**Re:** Case No. 20-417-EL-BGN -In the Matter of the Application of Grover Hill Wind, LLC for a Certificate of Environmental Compatibility and Public Need to Construct a Wind-Powered Electric Generation Facility in Paulding County, Ohio.

Second Supplemental Response to Third Data Request from Staff of the Ohio Power Siting Board

# GROVER HILL WIND, LLC 'S SECOND SUPPLEMENTAL RESPONSE TO THE THIRD DATA REQUEST FROM THE STAFF OF THE OHIO POWER SITING BOARD

Figure 1: Survey effort map with the revised boundary for the proposed Starwood project (November 2018).

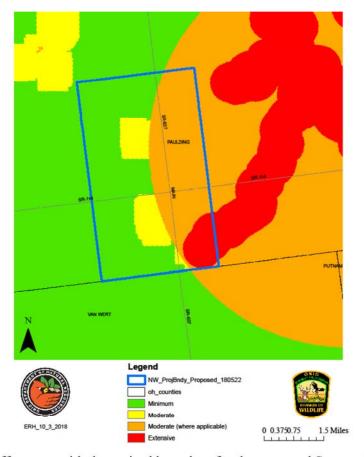
Currently portions of the project site fall within areas that DOW has identified as needing extensive monitoring efforts based on GIS analysis of the site. Migrating passerines and waterfowl are not expected to use the habitat consistently. Therefore, monitoring at the proposed facility is classified as "moderate" under the current protocols. If the developer decides to amend the current boundaries, the DOW will revise our survey recommendations.

Figure 1: Survey effort map with the revised boundary for the proposed Starwood project (November 2018).

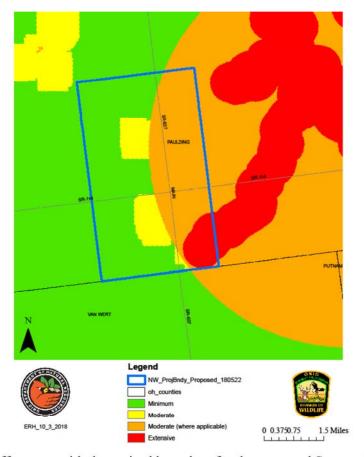
Currently portions of the project site fall within areas that DOW has identified as needing extensive monitoring efforts based on GIS analysis of the site. Migrating passerines and waterfowl are not expected to use the habitat consistently. Therefore, monitoring at the proposed facility is classified as "moderate" under the current protocols. If the developer decides to amend the current boundaries, the DOW will revise our survey recommendations.
